DECISION OF THE PLANNING ADMINISTRATOR

**PARTITION TENTATIVE PLAN / CLASS 3 SITE PLAN REVIEW CASE NO.: PAR-
SPR24-13**

SUMMARY: Multi-family development of 60 units as Phase II of the Gussie Belle Commons.

IN THE MATTER OF APPROVAL OF TENTATIVE PARTITION PLAN, AND CLASS 3 SITE PLAN REVIEW, CASE NO. PAR-SPR24-13 739 23RD ST NE)))))	FINDINGS AND ORDER FEBRUARY 4, 2025
--	-----------------------	---

PROPOSED SITE PLAN - PHASE II
 SCALE: 1" = 30'-0"

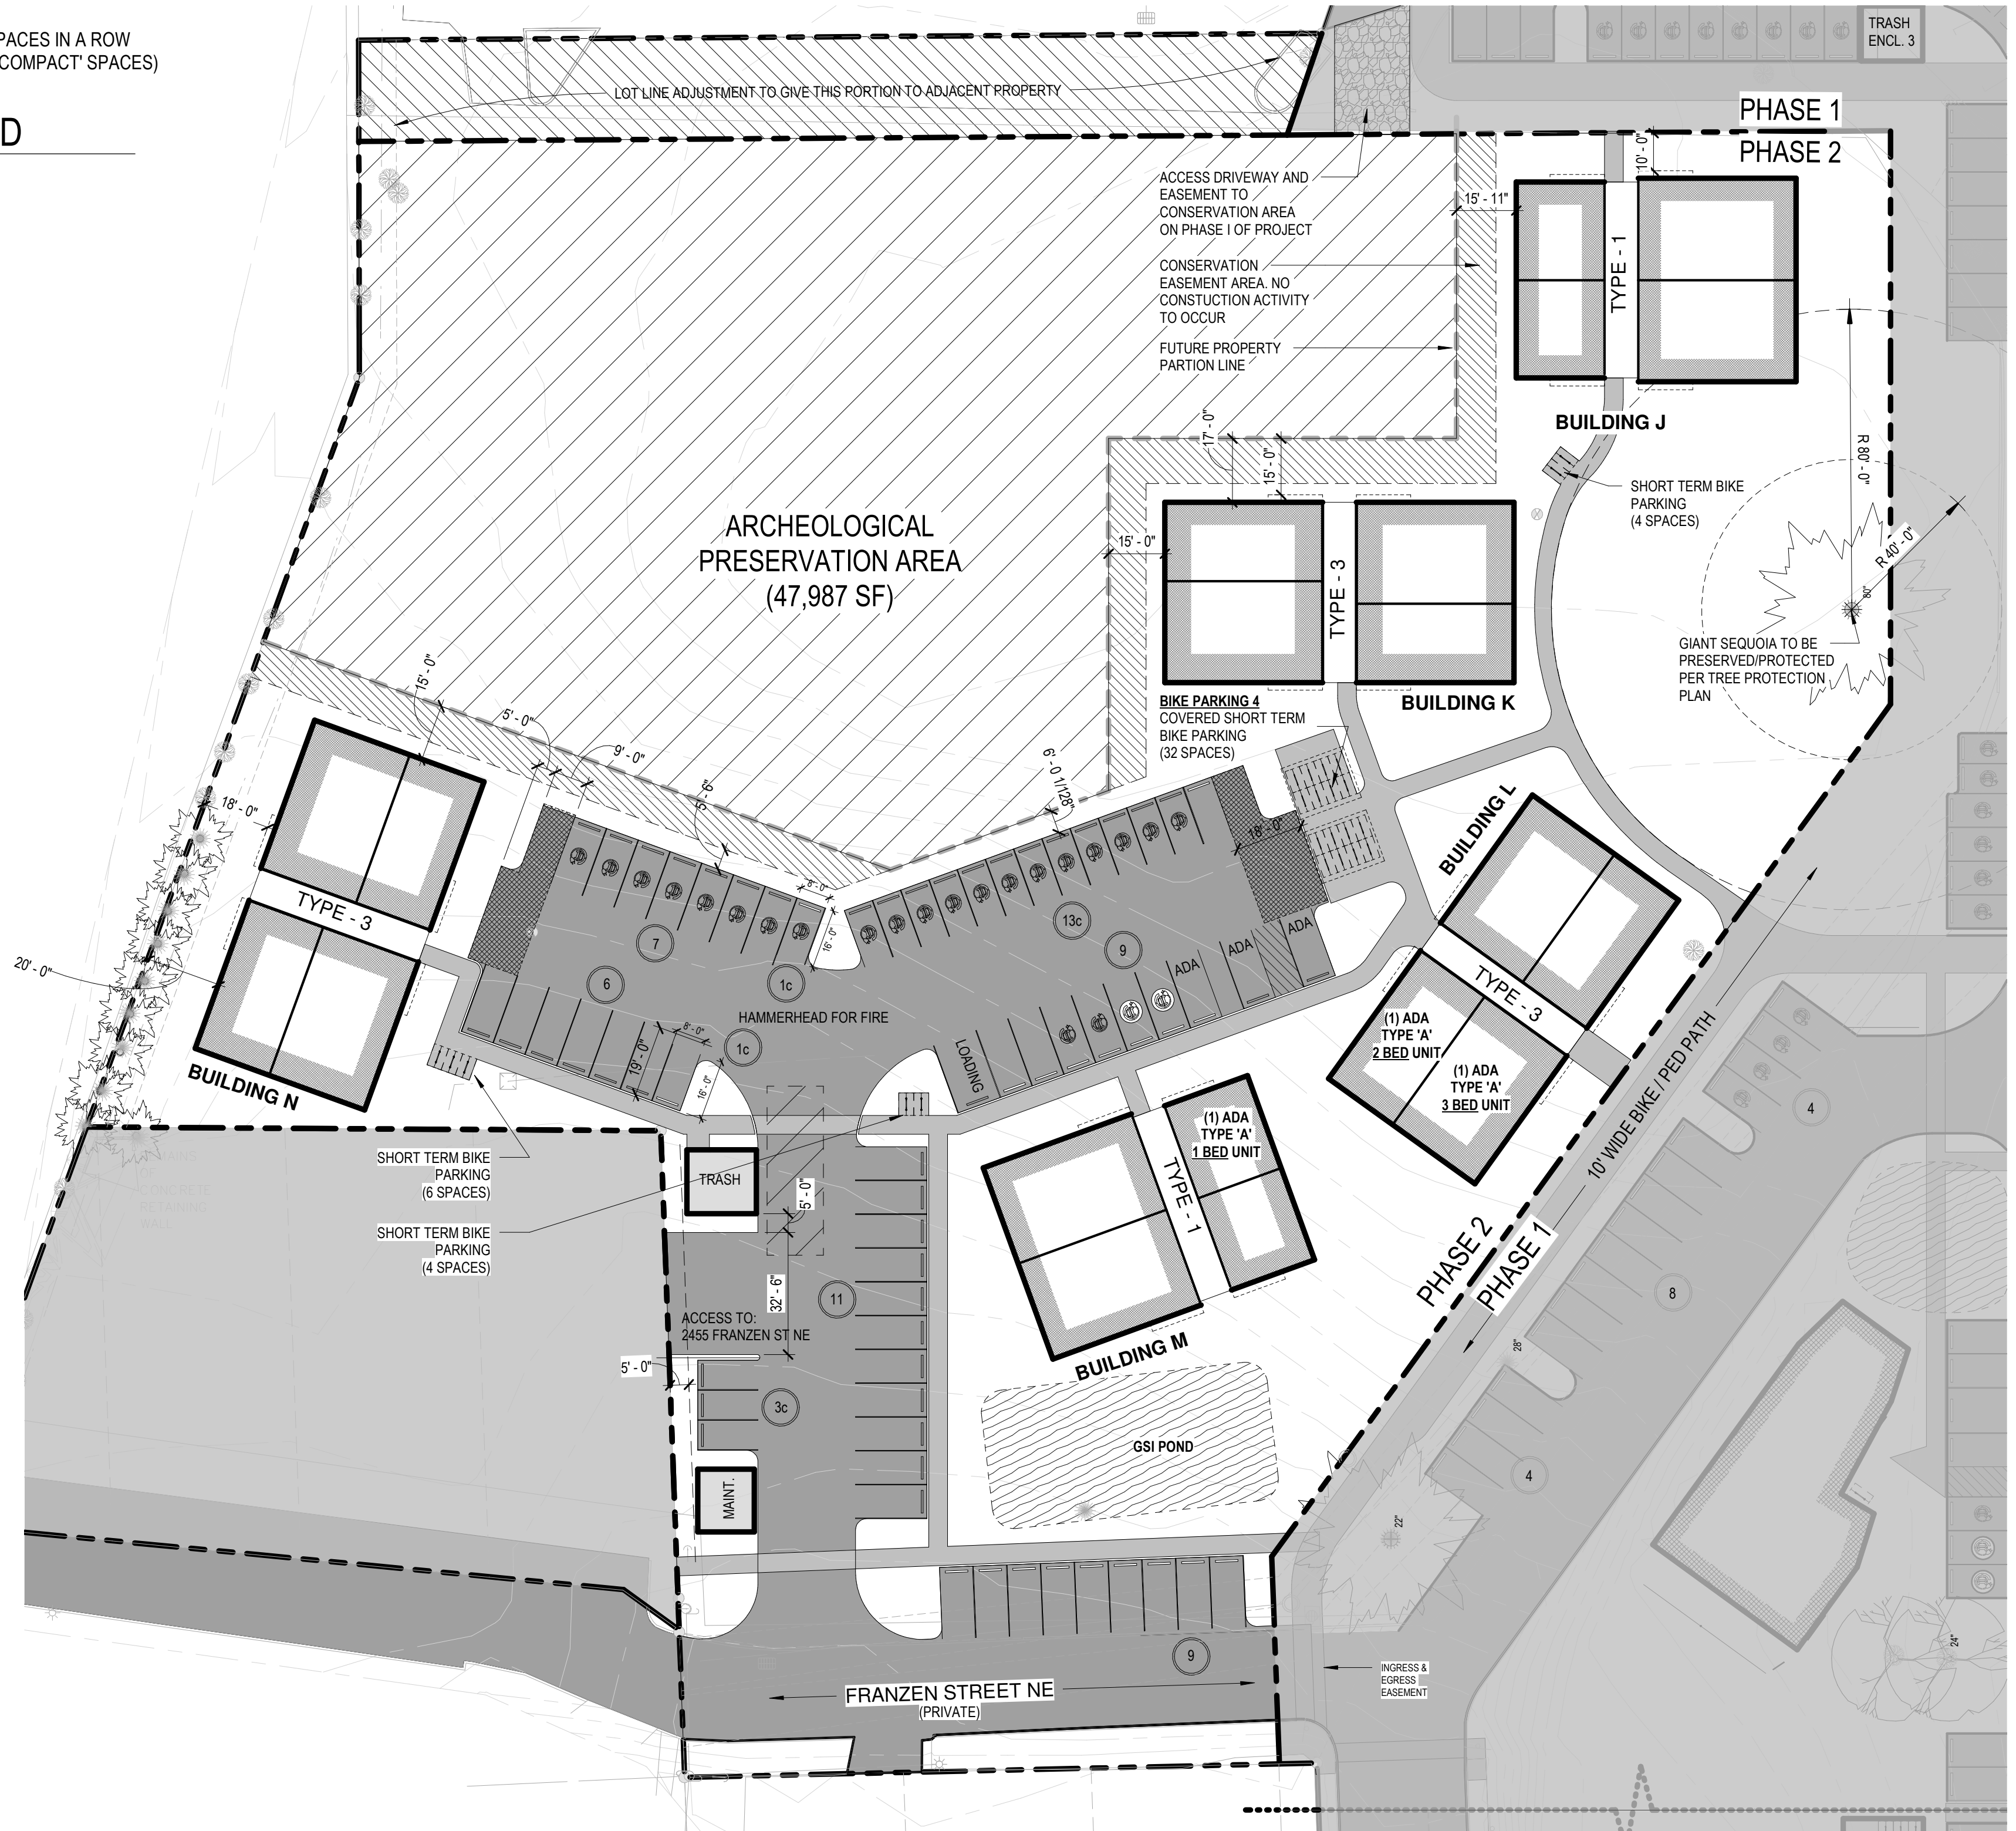
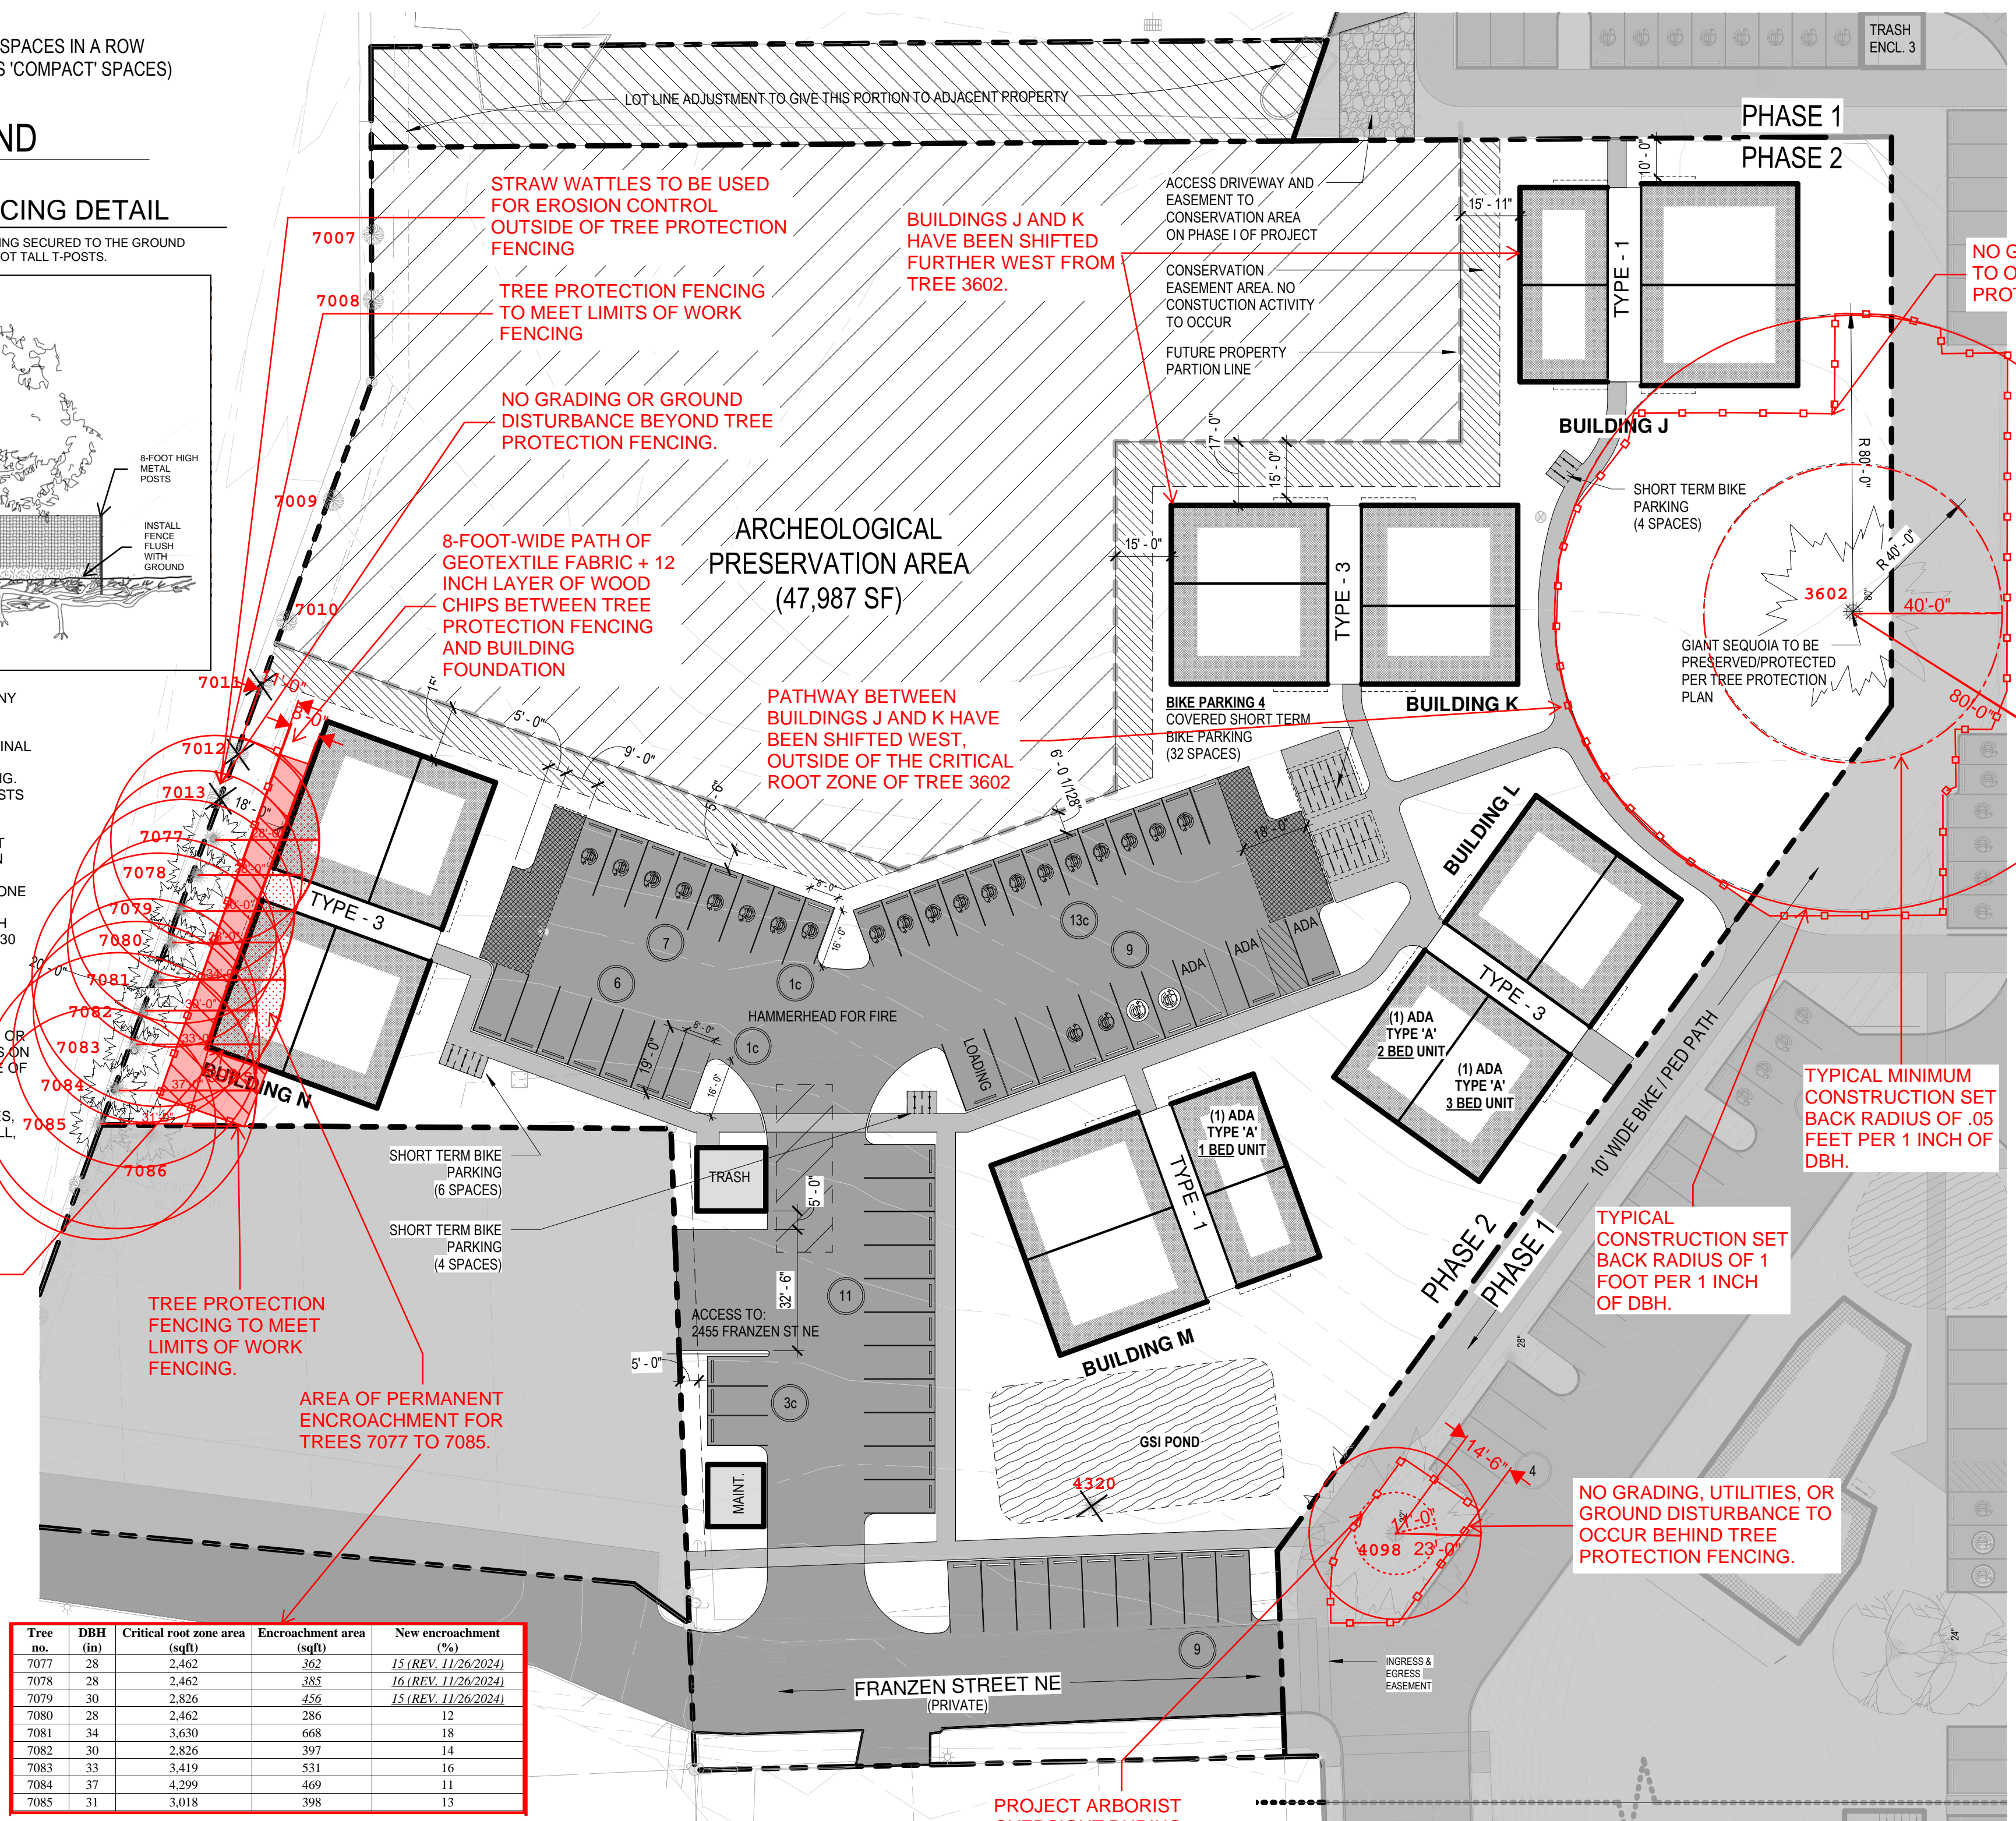
Condition 8: Construct a sidewalk along Franzen Street NE, as shown on the applicant's preliminary site plan, from the shared use pathway on Medical Center Drive NE to the western boundary of the subject property abutting Tax lot 073W24CC04100, and dedicate a public access easement along Franzen Street NE including the sidewalk.

Finding: The applicant's preliminary site plan shows vision clearance areas at all street intersections and driveway approaches. The proposal does not cause a vision clearance obstruction and meets the vision clearance standards established in SRC Chapter 805.

Finding: As shown on the site plan, the proposed development includes two off-street parking areas that terminate in a dead-end. The plans demonstrate conformance with the dead-end turnaround requirements for both area, ensuring the development is designed so that vehicles enter and exit the street in a forward motion with no backing or maneuvering within the street through a single, two-way drive aisle throughout the development. This standard is met.

Finding: The site plan indicates bumper guards will be provided for all parking spaces abutting required setback landscaping, or adjacent to a pedestrian connection; therefore, this standard is met.

- Condition 8:** Construct a sidewalk along Franzen Street NE, as shown on the applicant's preliminary site plan, from the shared use pathway on Medical Center Drive NE to the western boundary of the subject property abutting Tax lot 073W24CC04100, and dedicate a public access easement along Franzen Street NE including the sidewalk.
